REMARKS

Claims 1-41 are pending in the present application. By this Amendment, claim 42 has been added.

FIG. 6

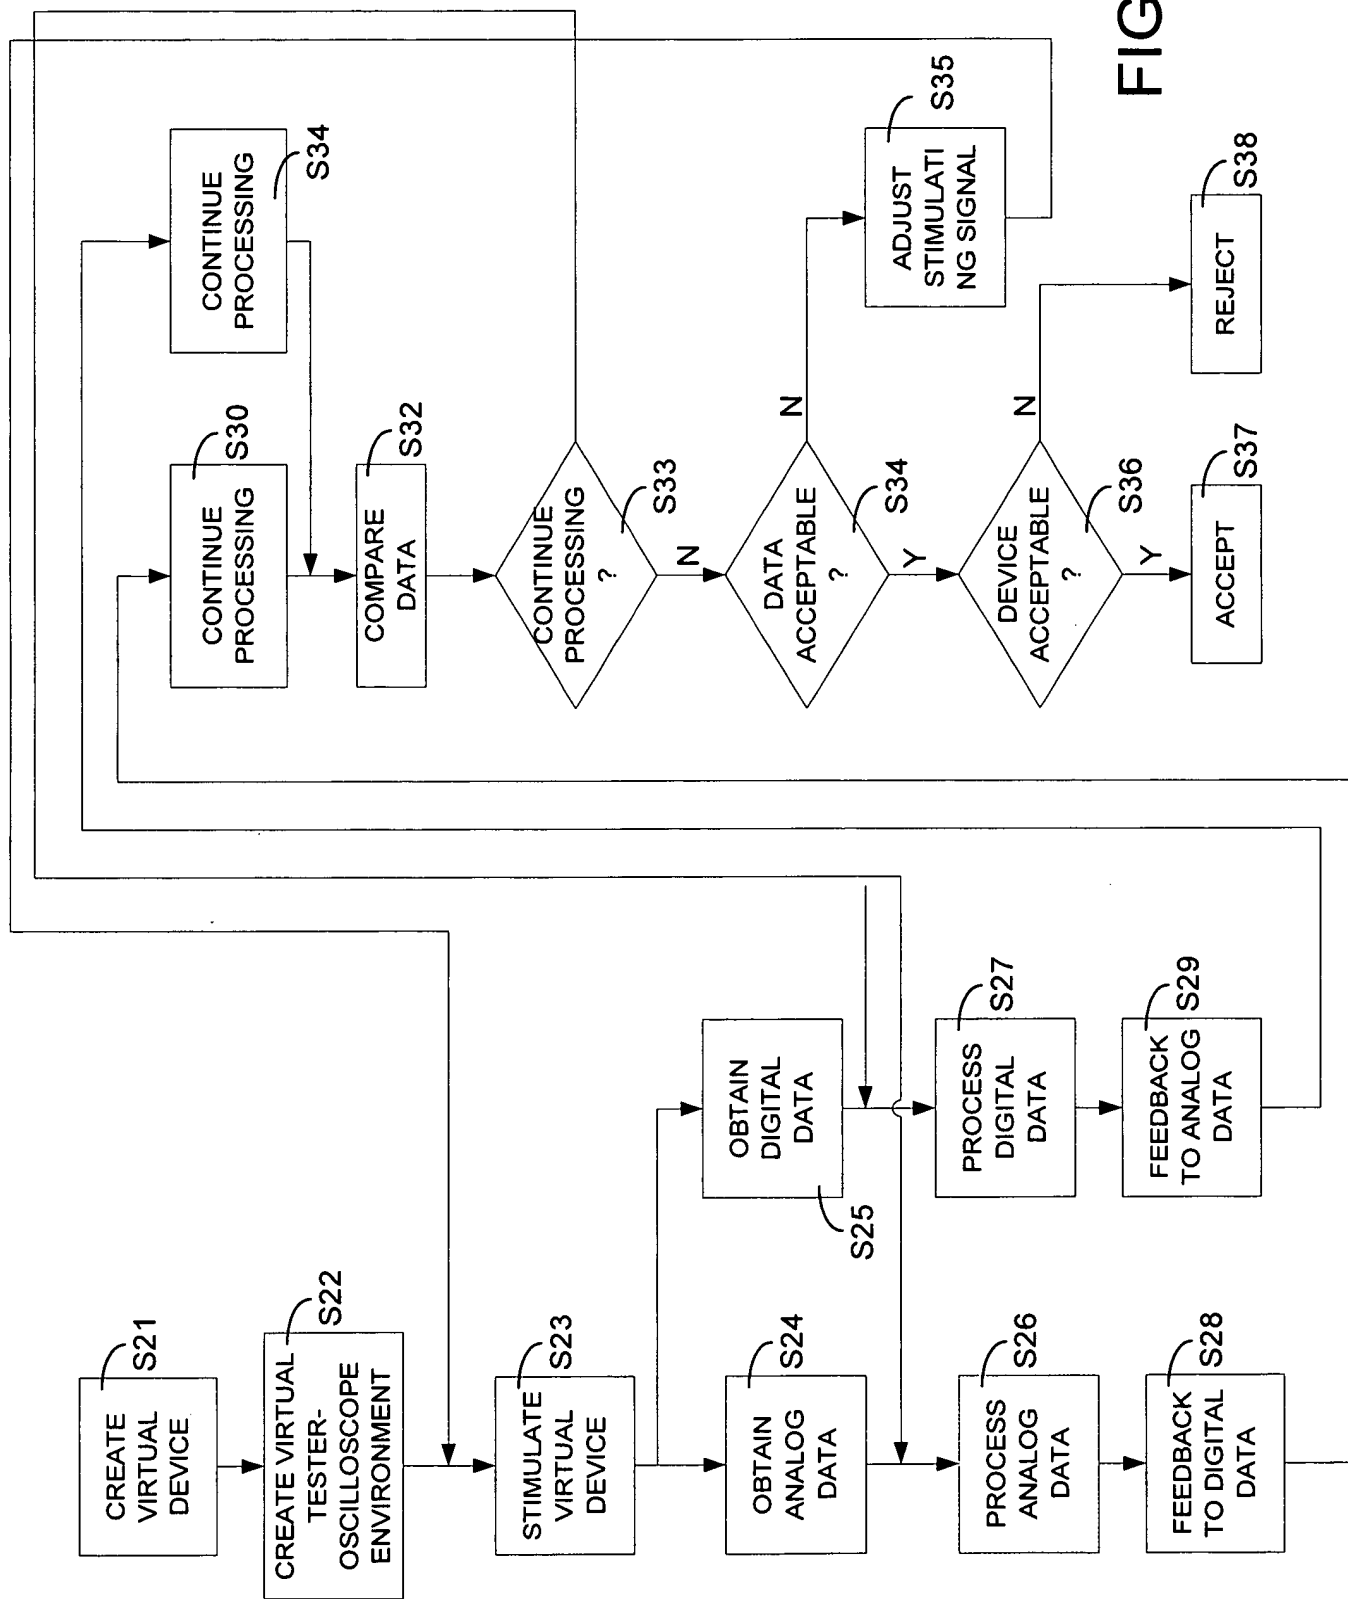
The drawings have been objected to for various reasons. Particularly, Figure 6 has been objected to for a minor informality. Applicants have amended Figure 6 so that the step of "Process Analog Data" is boxed in the same manner as the other steps. The Examiners also objected to the drawings for not showing some of the claimed elements of claim 14: comparison unit, first evaluation unit, and second evaluation unit. Figure 3 has been amended to include such missing elements. To comply with 37 C.F.R. § 1.84, Annotated Marked-up Drawings and Replacement Sheets of Figures 3 and 6 are enclosed herewith. In view of these amendments to the drawings, Applicants respectfully request withdrawal of these drawing objections.
